Addendum No. 3

August 10, 2011

Re: 1432-1438 Rosemont oh5-12b
261 Hoch Street oh5-18d

electrical service upgrades thru wall a/c unit replacement
1432-1438 rosemont oh5-12b
261 hoch street oh5-18d
dayton, ohio 45410
electrical plans

sheet
E4
1438 rosemont blvd.

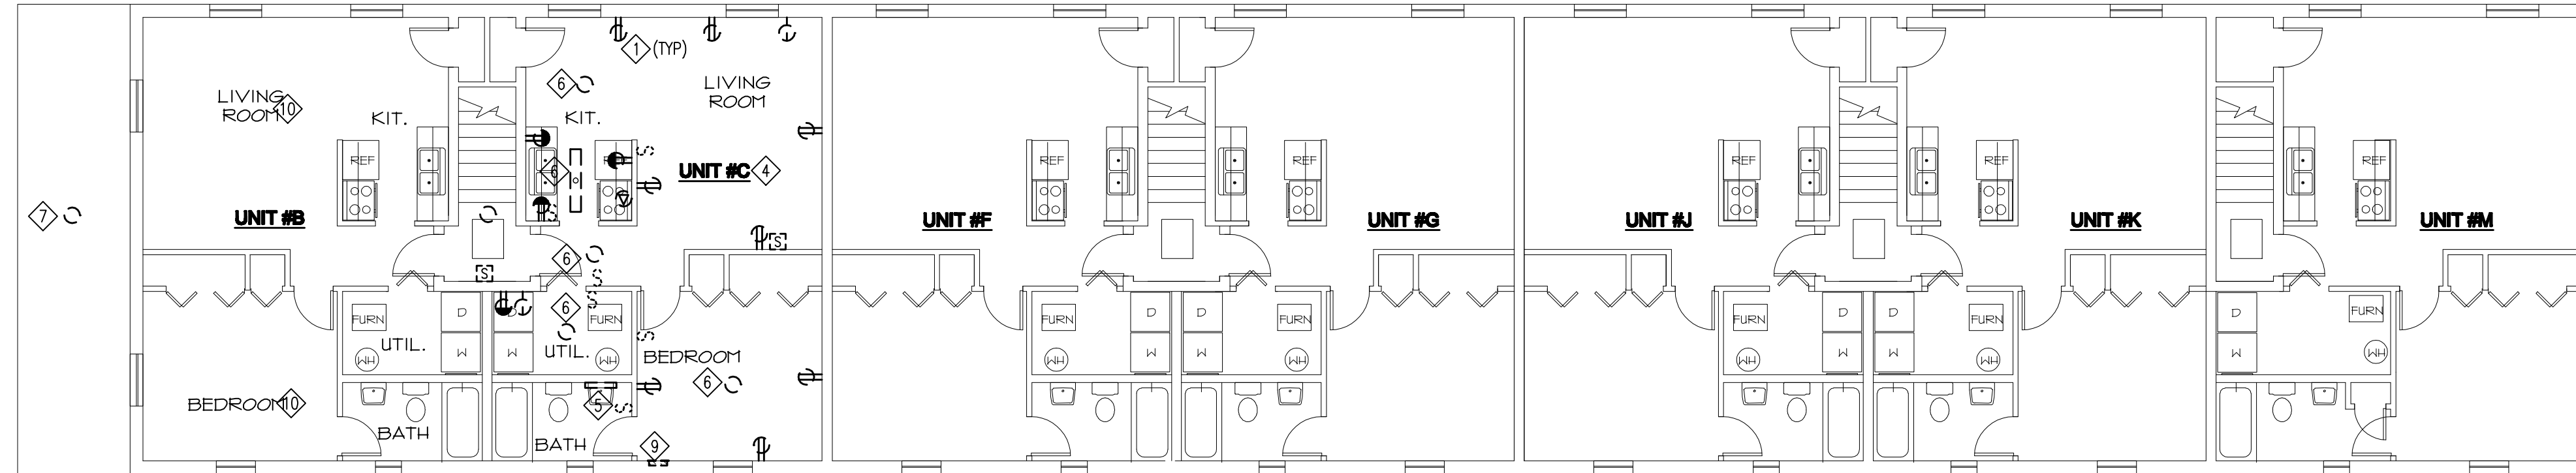
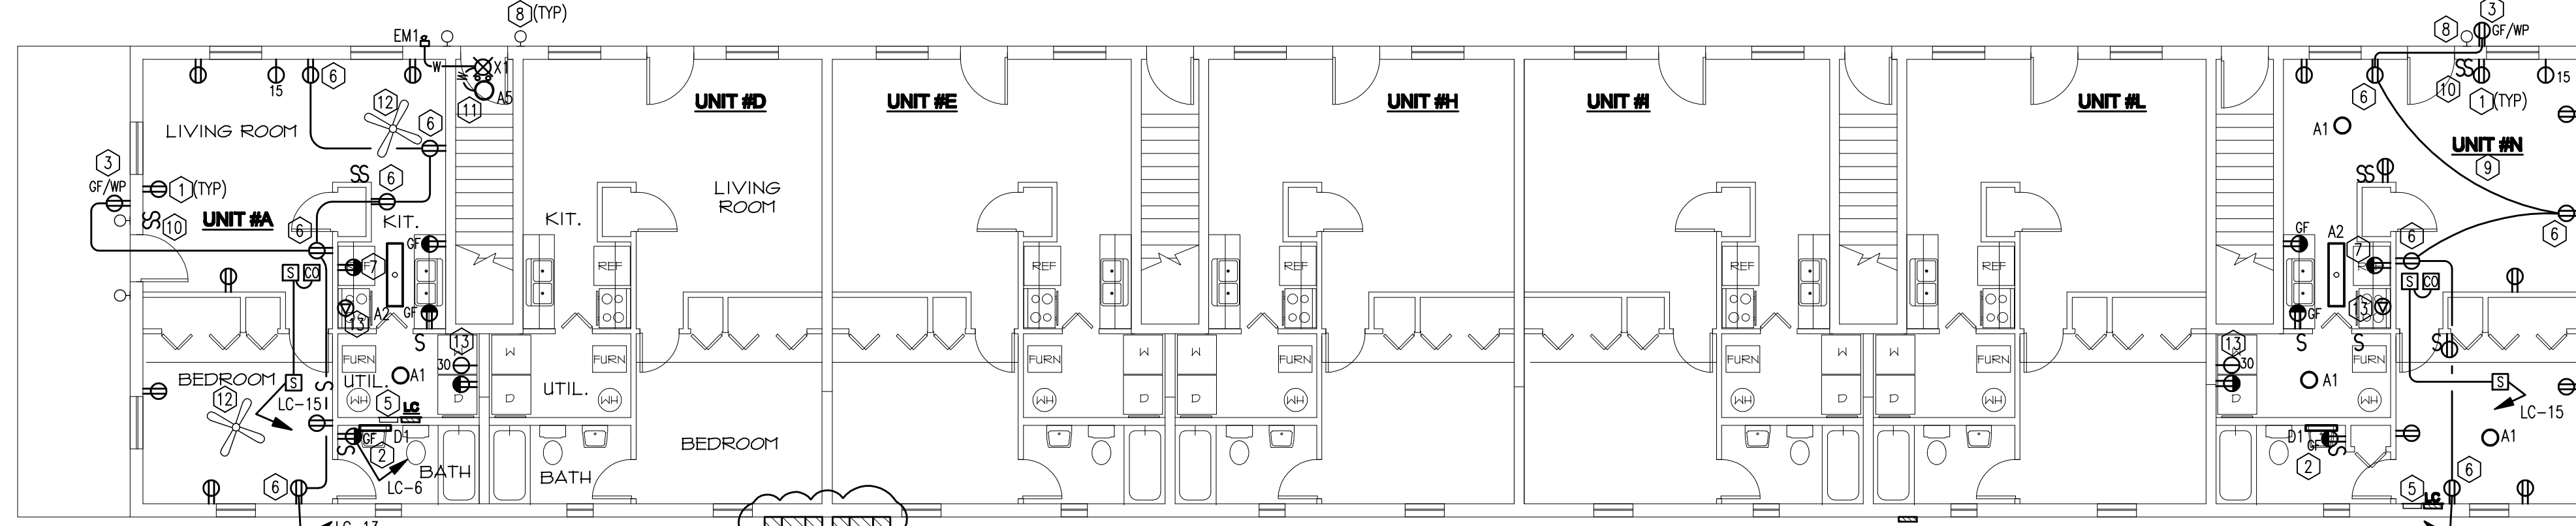
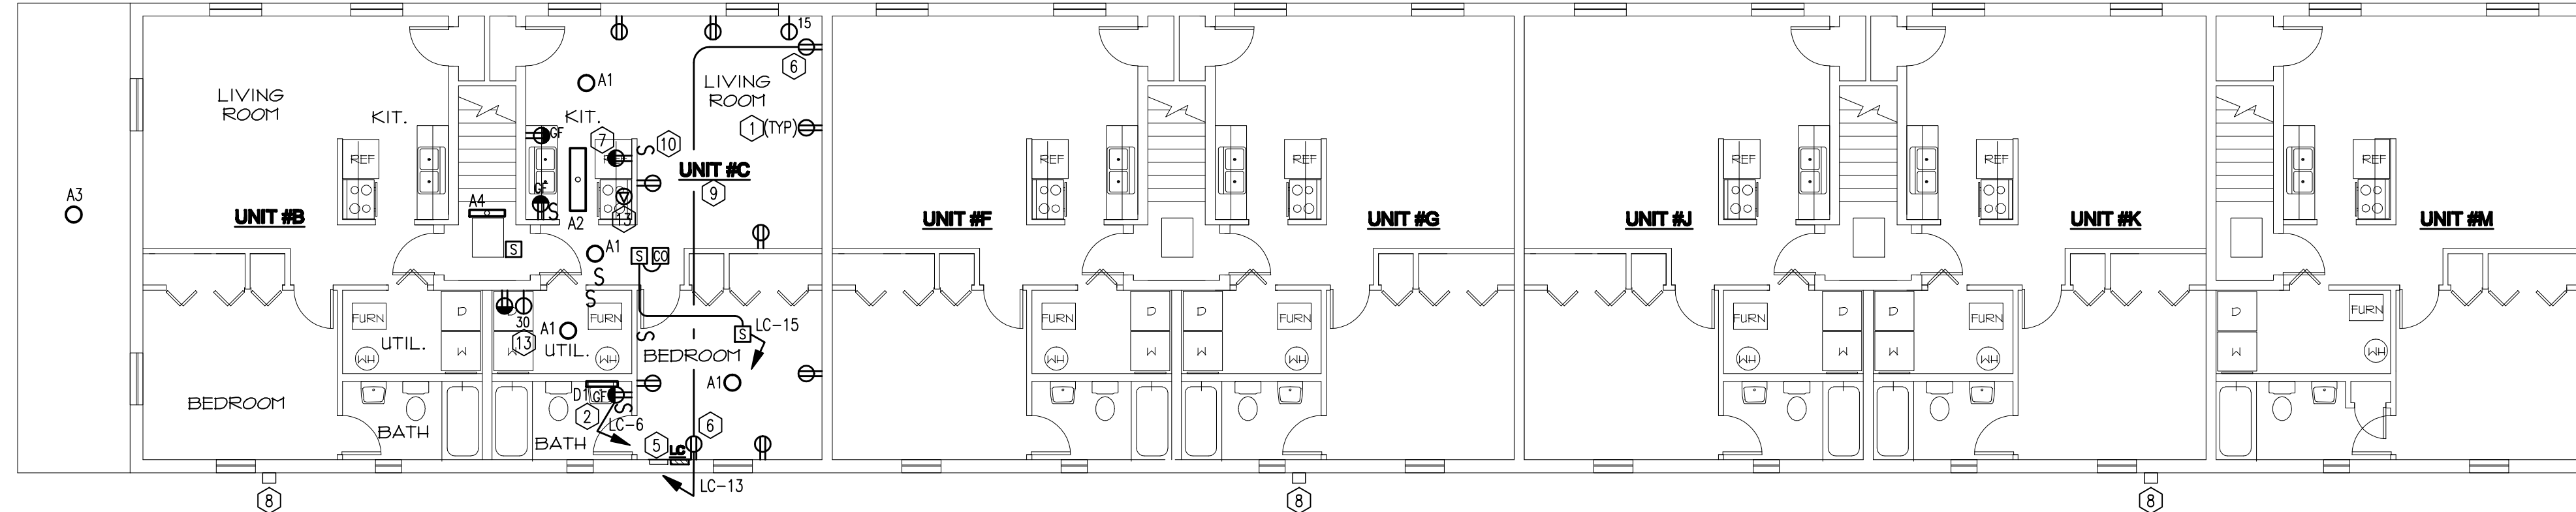
- Item No. 3: All penetrations of wall and floor assemblies between units or at stair enclosures shall be patched with materials to maintain the existing 1-hour fire rating. All penetrations for feeders or wiring shall be sleeved and fire stopped as required.
- Item No. 4: Attached revised Sheets E3, E4. Change: Apartment panel feeders extended from meter centers at buildings at Rosemont shall be installed to route through building interior in lieu of along length of building exterior brick face. Refer to revised sheets E3 and E4, note 5, and General notes B & C.

Item No. 5: Attached revised Sheets E1, E2, E3, E4. Change: References to alternate for maintaining range and dryer 3-wire circuitry have been deleted. Refer to sheet E2, clouded note 14 change, Sheets E3, and E4, clouded note 13 change, and Sheet E1, clouded notes 19 & 20 changes.

13. UNDER BASE BID, REPLACE 3-WIRE DEVICE WITH 4-WIRE DEVICE PER LEGEND NOTE 19, SHEET E1. REPLACE CORD ON RANGE/DRYER WITH 4 WIRE CORD. REPLACE BRANCH CIRCUIT WITH 4 WIRE CIRCUIT.
